LLFA Response

Selsfield Lane, Ardingly, West Sussex, RH17 6UG

Antler Homes plc
Knightway House
Park Street, Bagshot
Surrey, GU19 5AQ
Ref: 14267
Date: June 2026

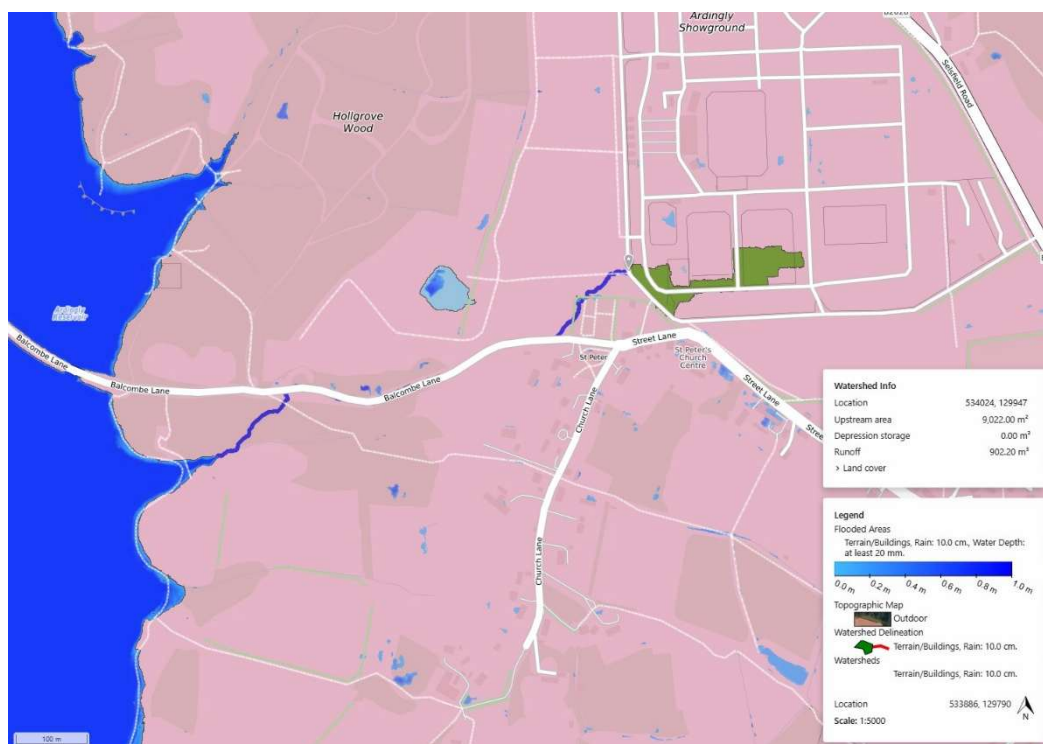
- 1.2.2. There are several comments raised during the pre-app which are not met. These are:
- i) *Evidence of the ditch's connection to the wider watercourse network and reservoir, however this must be demonstrated at Reserved Matters, to ensure this is a viable method of draining the site.*

2. The below image taken from the Scalgo software indicates the connectivity route from the proposed outfall to the existing reservoir. The flow follows Balcombe Lane before entering the reservoir easement. The proposed access road provides an area on the northern side of the basin to undertake maintenance tasks. 3m is available for the majority of the perimeter with the exception of some of the southern edge. We feel this is suitable for the likely maintenance tasks involved. Drawing 14267_1604 is provided in Appendix B indicating proposed sections through the basin.

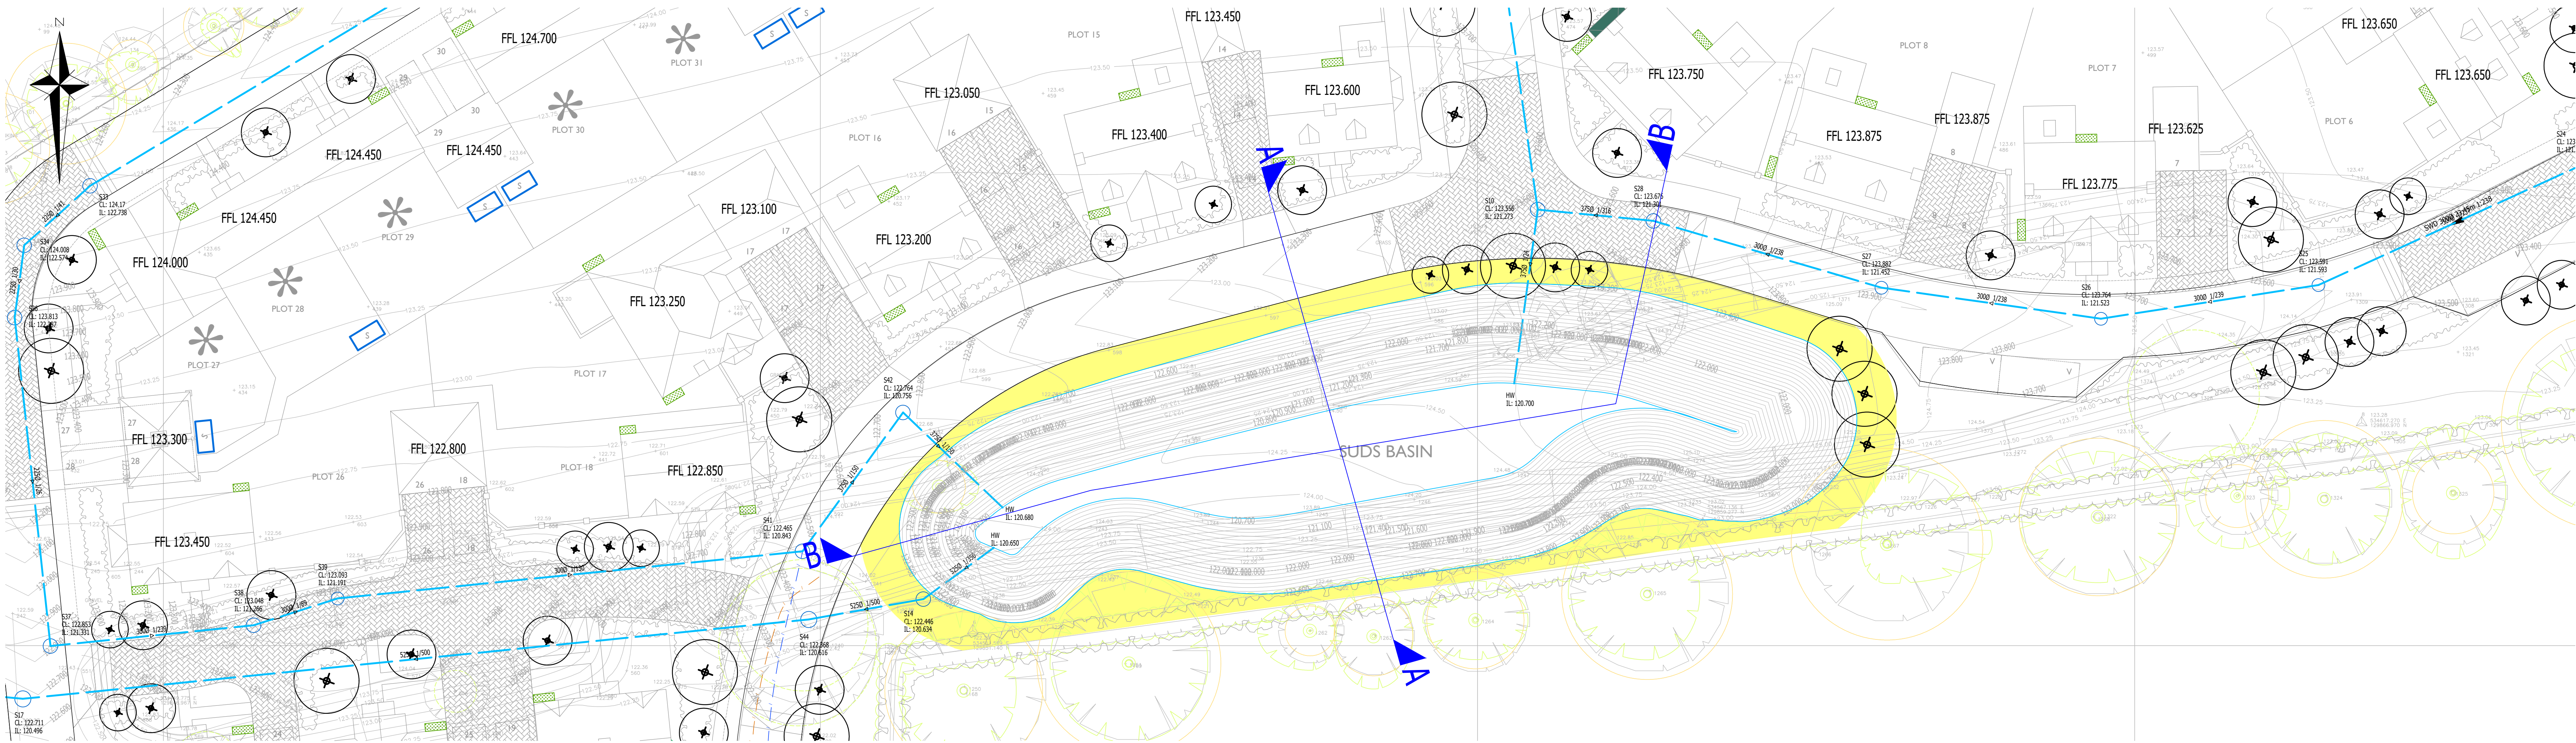
- 1.2. The below list outlines the comments and queries to address within this report:
- 1.2.1. In July, the National Standards for SUDS (NSfS) were updated. We require evidence that these are followed, in particular to Standard 2. The site currently uses no source control SUDS features. We would suggest that these shall be included to meet the NSfS. The use of source control SUDS features was also raised by MSDC Drainage at outline stage and within the LLFA pre-app in 2024. *Please can the applicant provide a contributing areas plan for the areas covered by the interception proposals. Discharge of condition requires detailed design and as such we will need to see confirmed location and detailed design, including connectivity, for SuDS planters and permeable paving proposed.*

1.2.6. While SUDS planters are mentioned in 10.6, the location of these are unclear. Please refer to Point 1.

1. SUDS planters are proposed to cater for the initial 5mm of rainfall associated with most dwelling roofs (total area of 2055 square metres). The dry basin will cater for approximately 1300 square metres of carriageway with a total road area draining directly to the basin either by gravity or pumped of 3702 square metres (This equates to approximately 35%). Additional swales, one alongside the western residential road and a second prior to the outfall will provide interception of a further 500 square metres (275 square metres directly with remainder downstream). Therefore, in total 49% of the road network will have some form of interception. All private drives will be lined permeable paving and therefore comply. It should be noted that infiltration tests have been undertaken and no rate could be established due to the impermeability of the soil.
The permeable paving will be connected to the positive drainage network via diffuser and suds planters will be connected to the positive drainage in accordance with manufacturers recommendations, the private drainage network will be finalised during the next design stage.

Contributing areas plan (14267/1605) provided with resubmission.

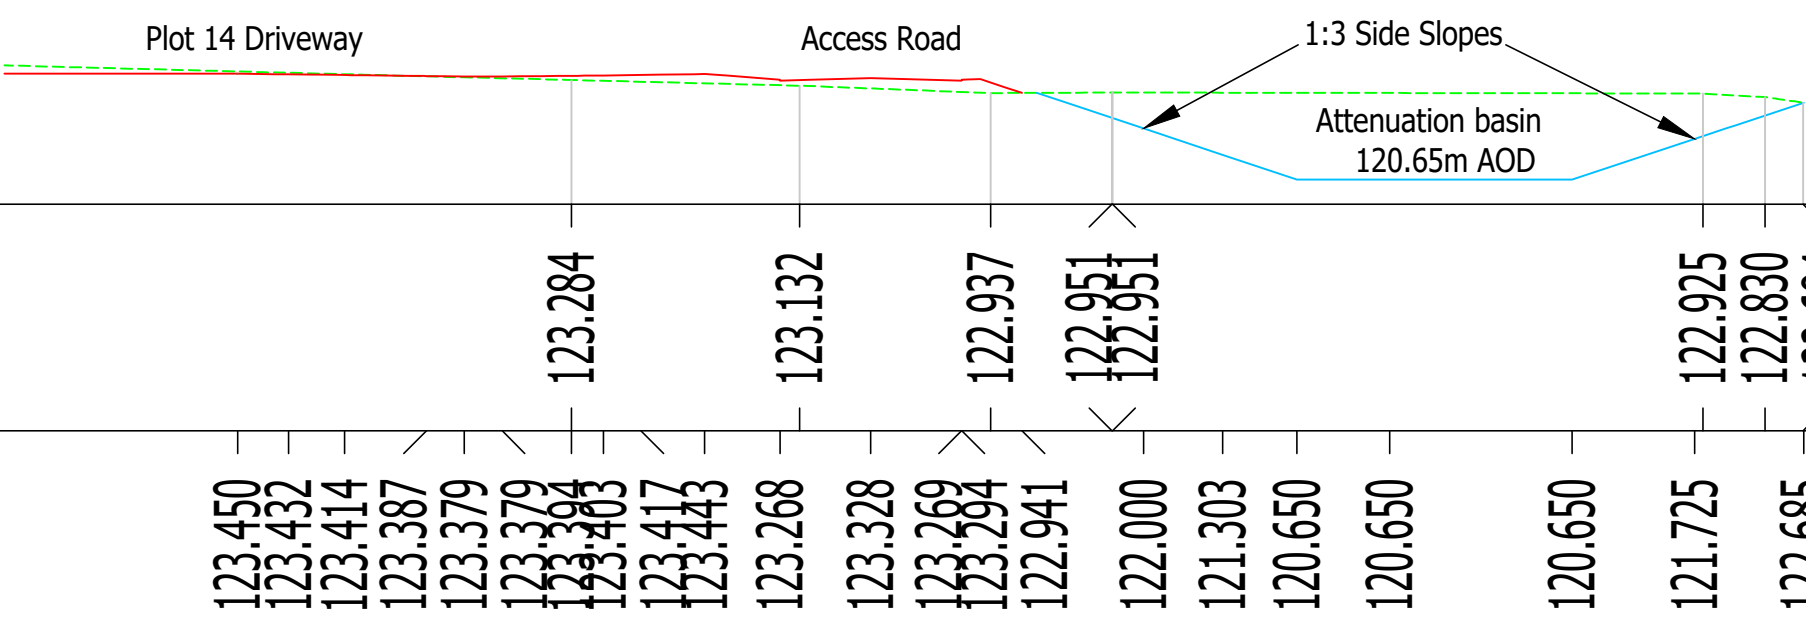
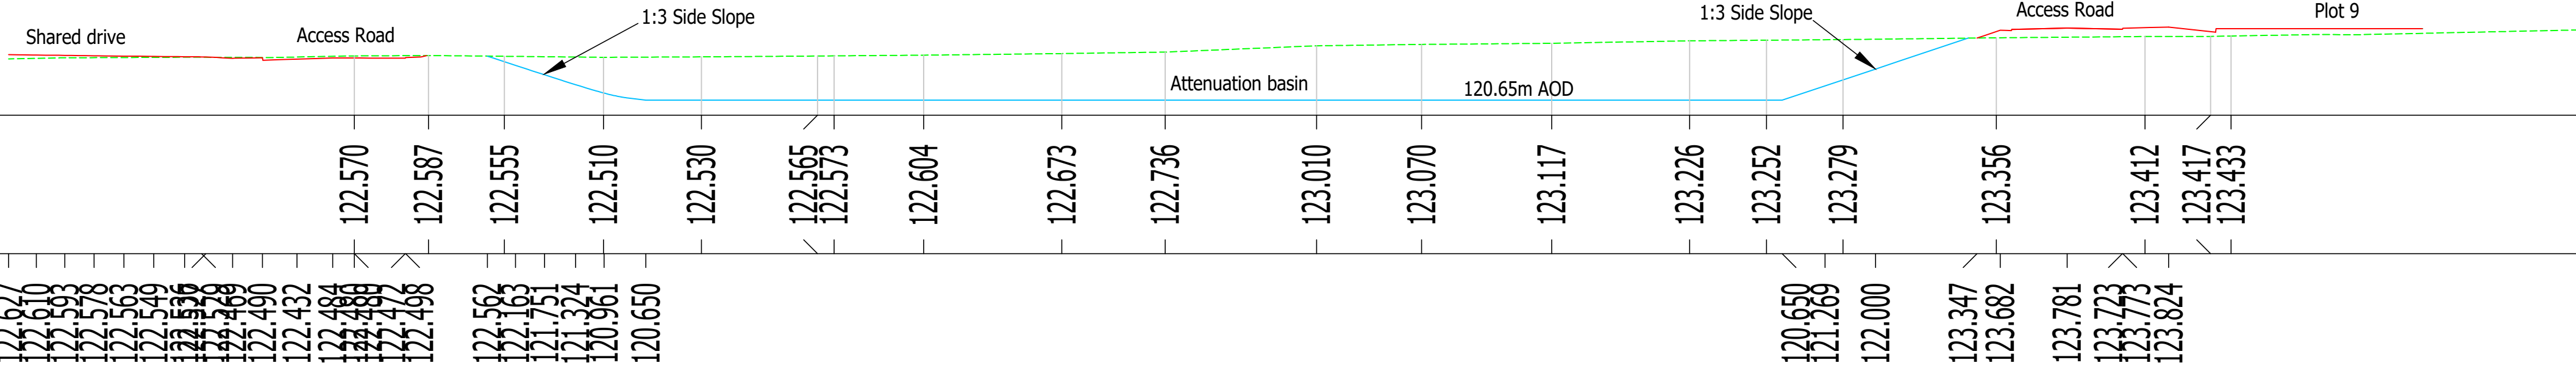
- ii) *A 3m easement around the basin and nearby off-road parking for maintenance access is required.*
 - iii) *Basin cross sections required. It is recommended the basin is designed using guidance in the SUDS manual.*

1.2.7. Part of the basin is designed with 1:2 side slopes, which does not follow SUDS manual.

7. Basin design has been updated with maximum side slopes of 1:3.
8. Flood volume and area now shown on drainage layout drawings. A depth of 50mm is assumed.
